# M-13 Revision 91

# Summary of changes

M-13 Version 91 Revisions

# DOE-417 reporting

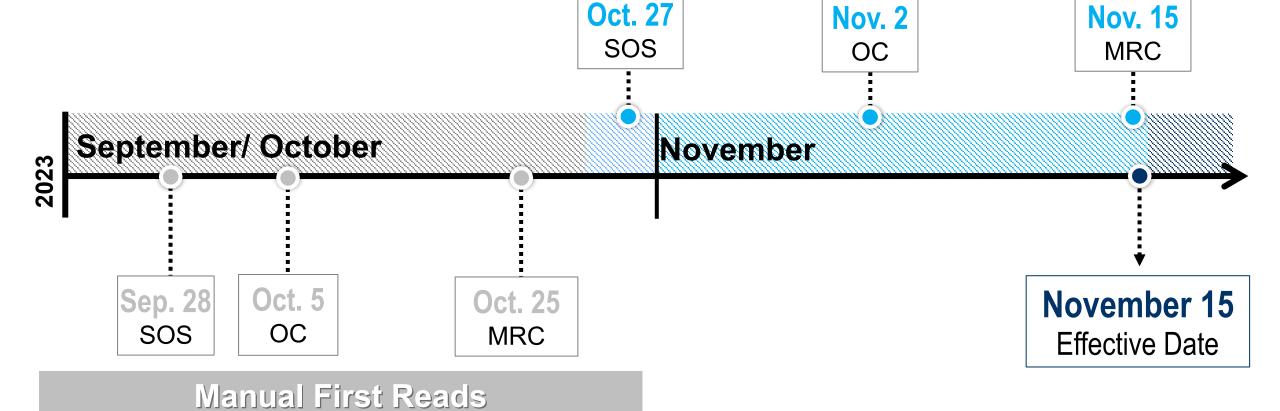
- Section 2.3.2 Note added
  - If public appeals to conserve electricity is issued, during any of the below steps PJM Dispatch notifies impacted members via All-Call, post to Emergency Procedures page, and submit DOE-417 report to DOE, NERC and RF and/or SERC.
- Section 2.3.2; Section 5.2 Steps 9, 10 notes added there to submit DOE-417
- Section 4.3, 4.4, 4.4.3
  - Notes added under PJM actions to submit DOE-417 reports
